MONTICELLO NUCLEAR GENERATING PLANT
Docket No. 263 License No. DPR-22

Redundant Reactor Building Crane

Responses to Request for
Additional Information

Changes and Corrections to Design
Report for Redundant Reactor Building Crane

FIGURE 1

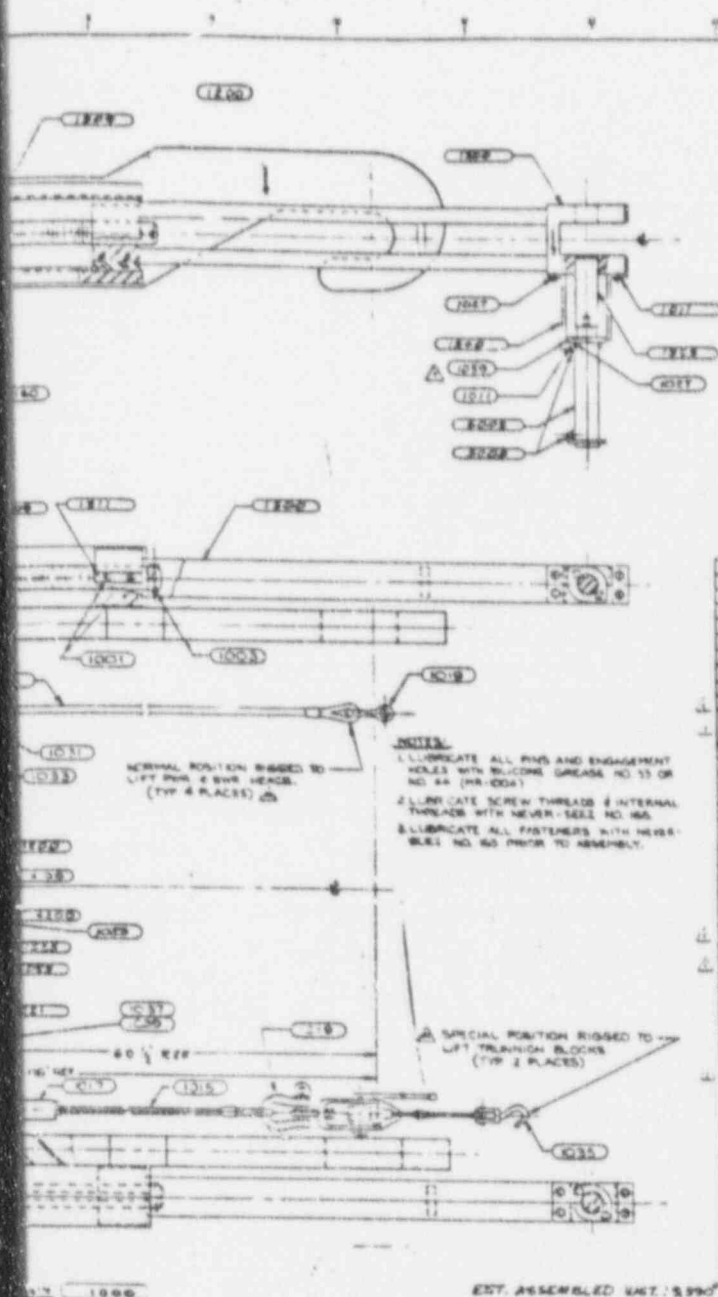
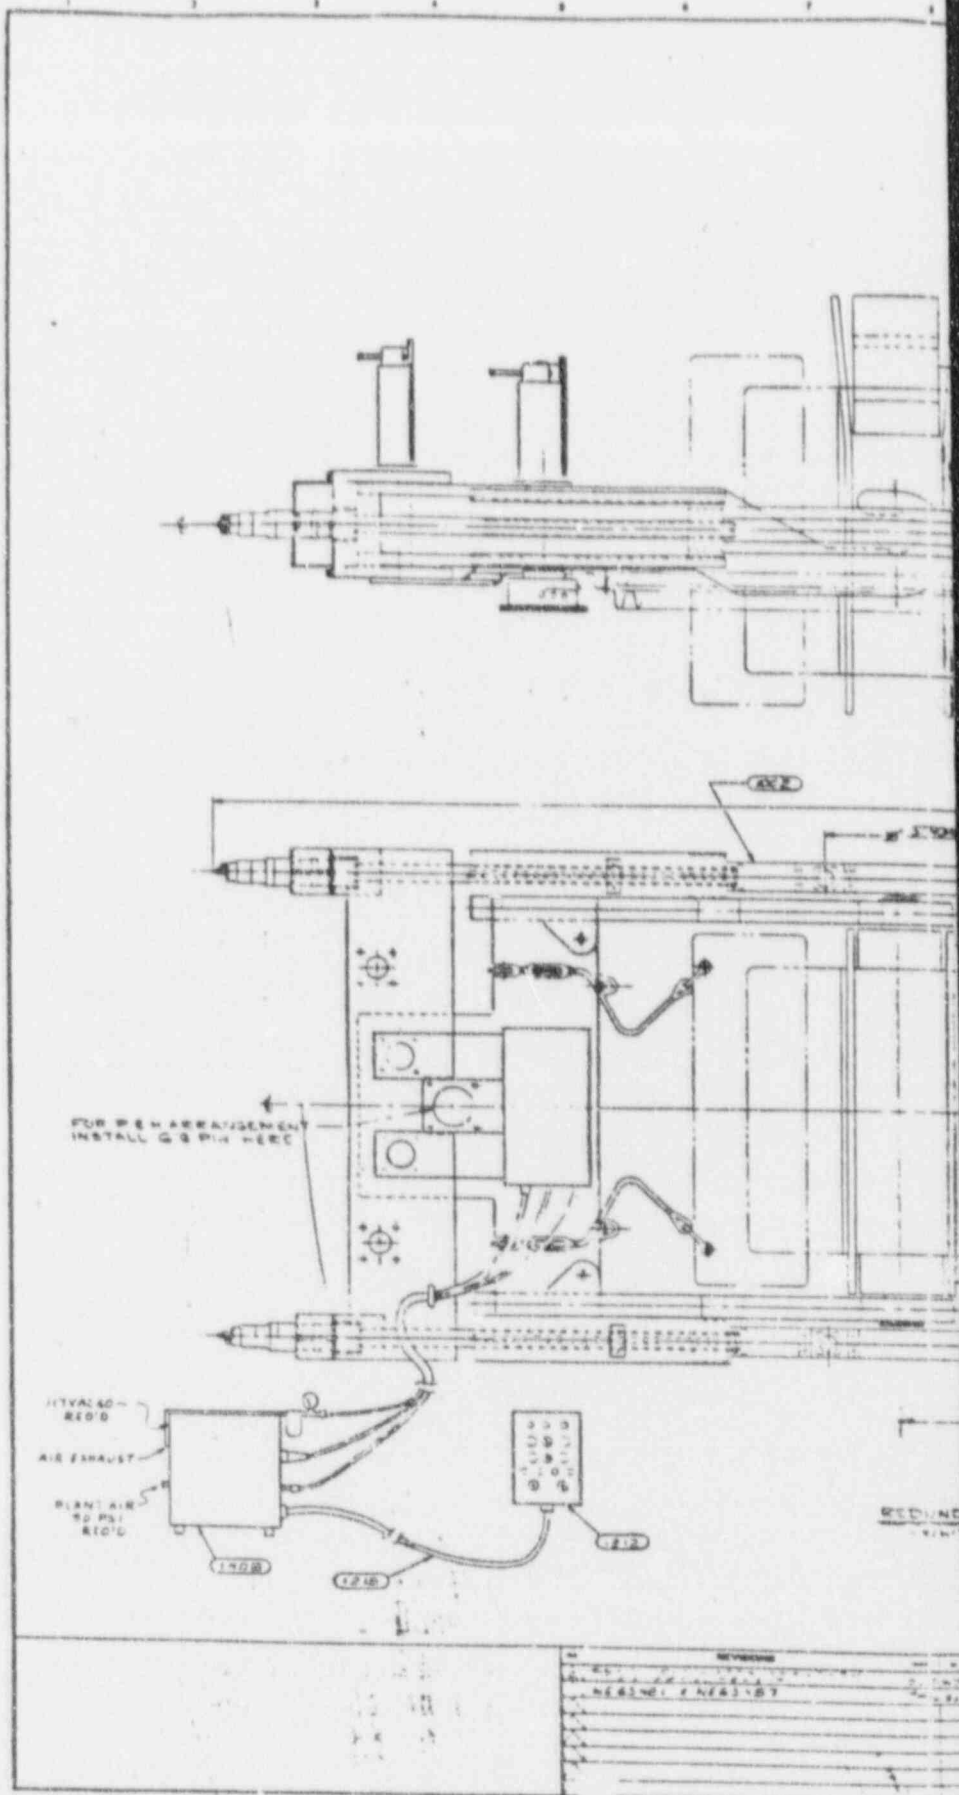
QUESTION 8: Indicate which of the two IF-300 shipping cask handling yokes will be utilized in the Monticello Nuclear Generating Plant. Discuss and compare the relative merits and disadvantages of the two handling yokes as their requirements relate to the limitations at your facility.

RESPONSE 8: Northern States Power Company will use the "redundant IF-300 cask yoke". The non-redundant yoke will not be used. Drawings of the redundant yoke are shown in Figures 1 and 2.
